PRATT & WHITNEY CANADA
TOOL SERVICE BULLETIN

NO: PW200-26R1

Description: Sealing Ring Drift

Subject: Sealing ring drift - Modification of

Figure 1

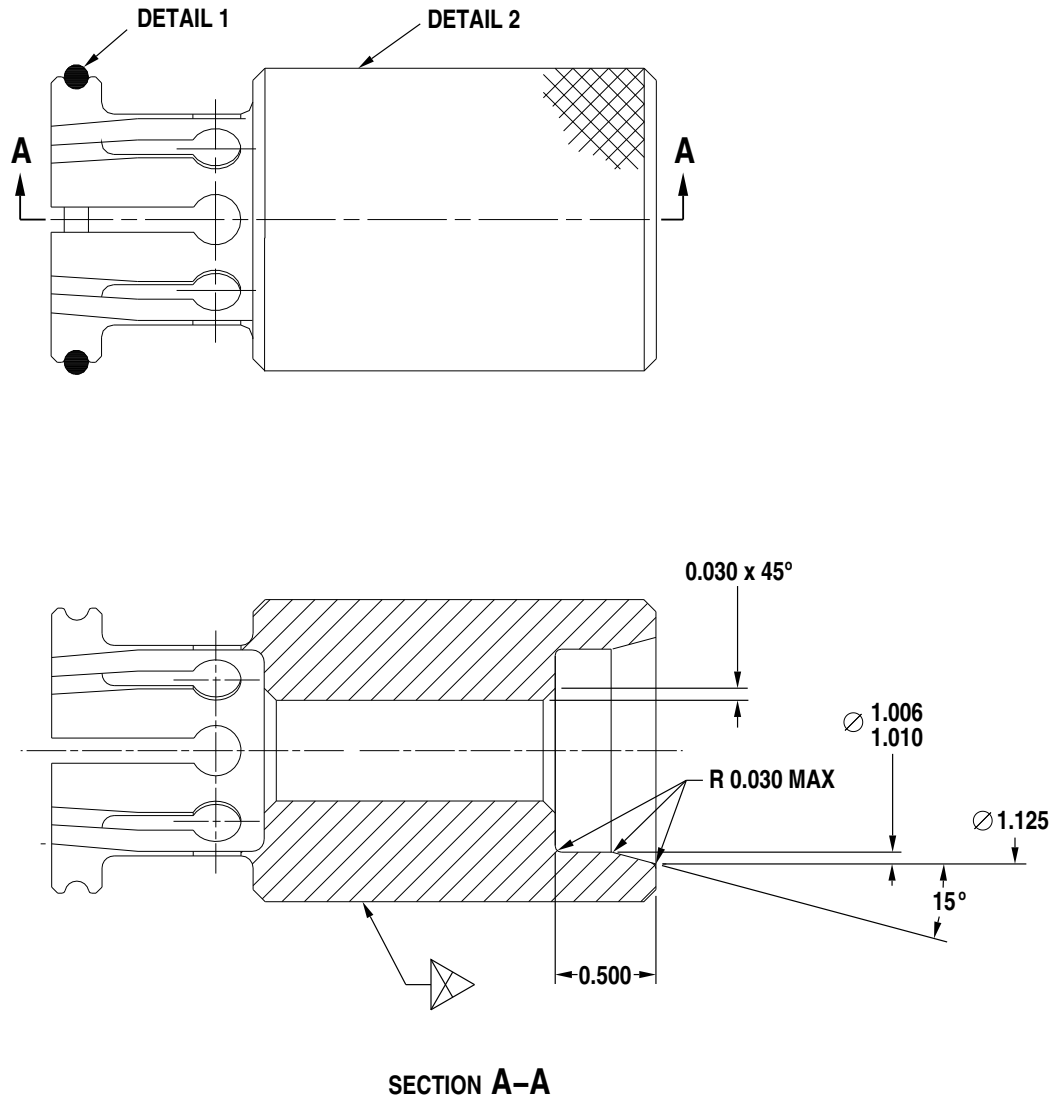
Problem: No compression on seal ring after installation.

Solution: Make a counterbore and taper the end of the tool.

Instruction: 1. Remove packing detail 1 from sealing ring drift detail 2 and retain (Ref. Fig. 1).

2. Rework the sealing ring drift and break sharp edges.
3. Reidentify the reworked tool to change letter "B" following existing P/N PWC64245 using the permanent marking method per MIL SPEC 130.
4. Reinstall the retained packing detail 1 on sealing ring drift detail 2.
